AS Project NCR List Related to Dyson (PMIV)

Contract #: 04-0120F4

QUALITY ASSURANCE -- NON-CONFORMANCE REPORT

Report No: NCR-000124

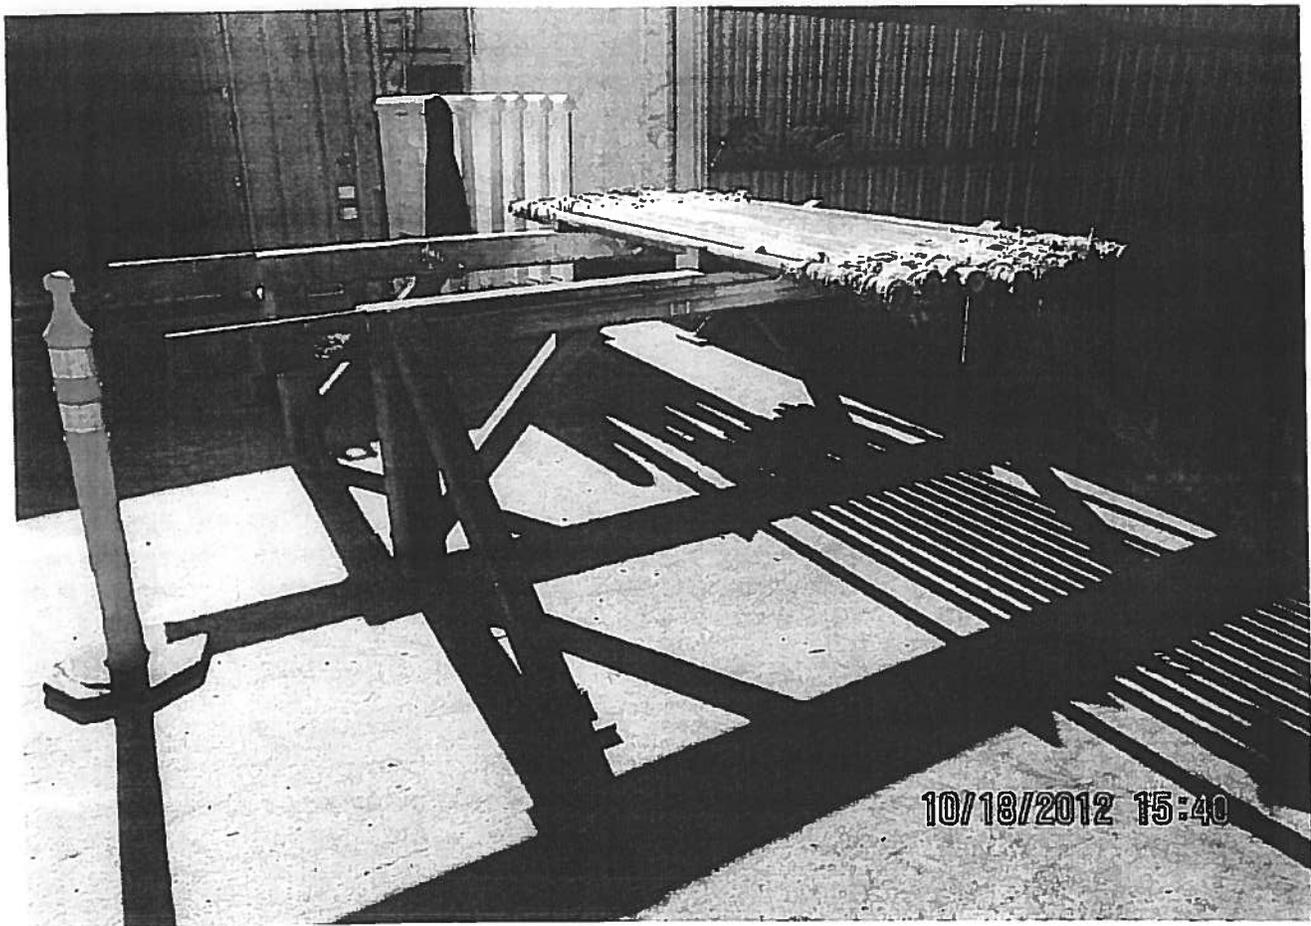
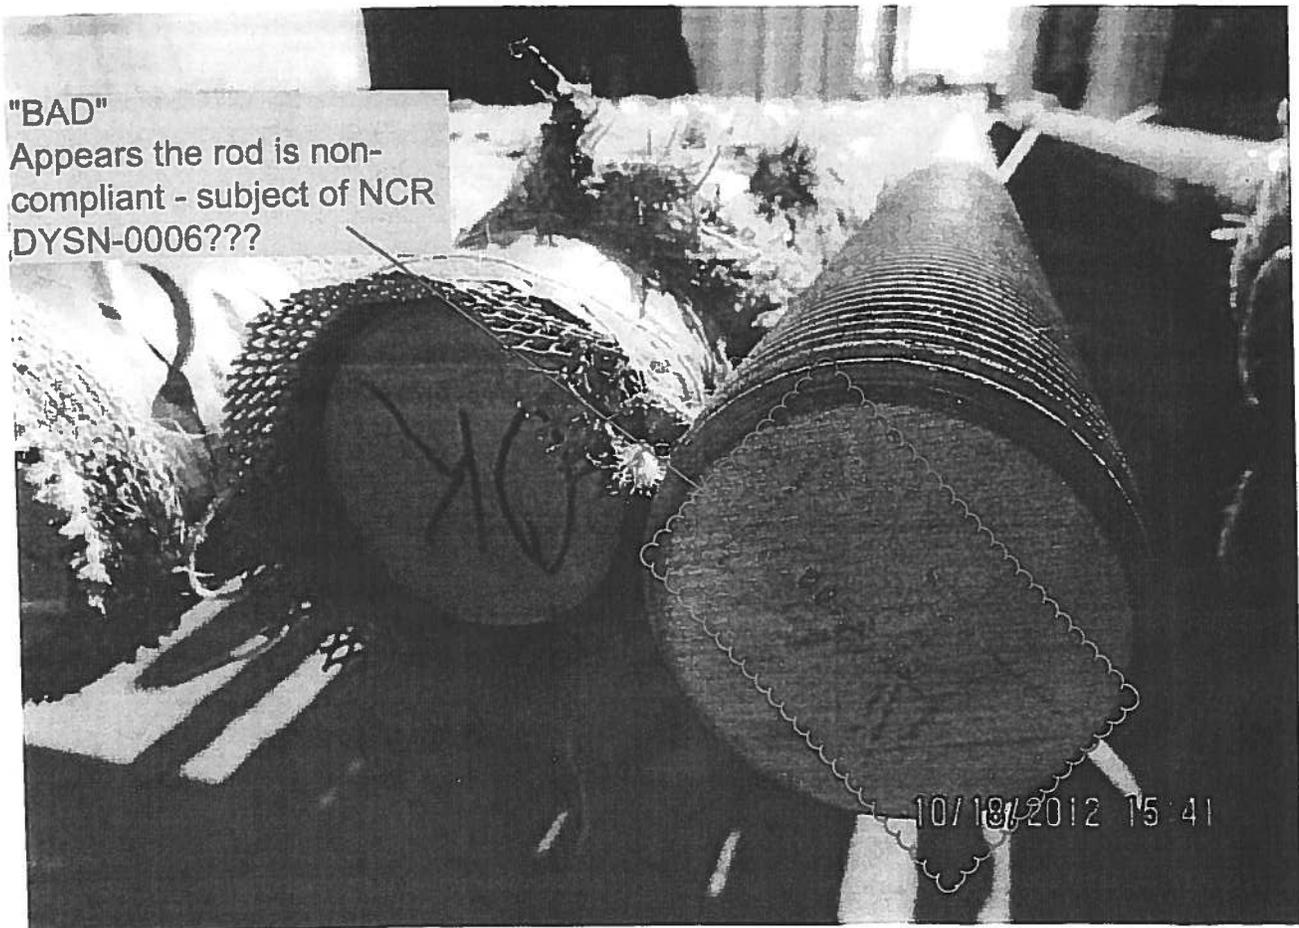
In the interim, I wondered if you can shed any light on a B14 Anchor Rod that appears to have been marked up as "Bad" - see attached photo. Is this one of the rods that is subject of the NCR?

"BAD"
Appears the rod is non-compliant - subject of NCR
DYSN-0006???

I am aware of one rod that had nicked threads at one end. The rod with damaged threads is the same length as one of the rods that we need to cut. The length of damaged threads falls within the area that needs to be removed.

I cannot recall if the rod was marked as "bad." I will verify this afternoon if there is another rod that has some type of damage.
